**SB-10054008-5231**

SI B11 06 13  
Engine

**Service Action: Retrofit Bracket for EGR Cooler**

E70 (xDrive35d)

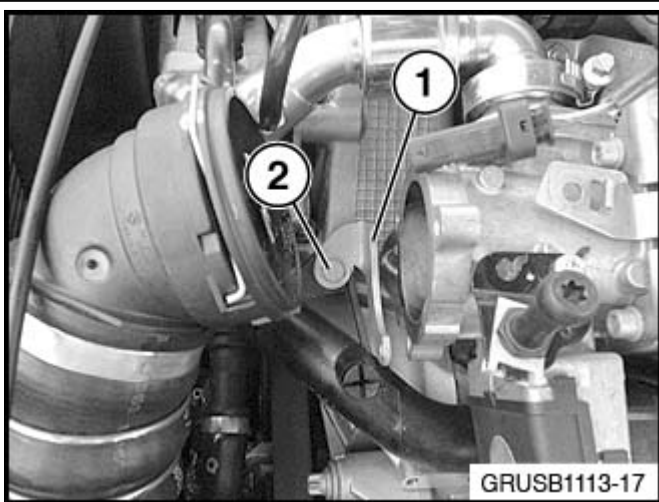
The flexible pipe on the high-pressure Exhaust Gas Recirculation (EGR) cooler may leak.

Excessive vibration and/or tension at the flexible elbow of the EGR cooler can cause it to leak.

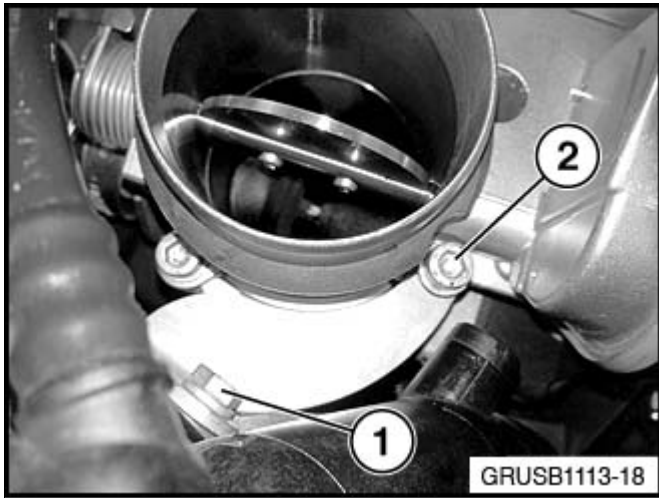
Install bracket P/N 13 54 8 576 446 (1) to the cylinder head using the bolt P/N 07 11 9 904 527 (2). Leave this bolt finger tight until after the throttle valve is reinstalled.

Reinstall the throttle valve and snug down all three throttle valve screws. Torque the two screws that are not attached to the new bracket to specification (8Nm). Tighten down the bracket bolt on the cylinder head (1) to 8Nm. Tighten the screw (2) holding the bracket to the throttle to 8 Nm.
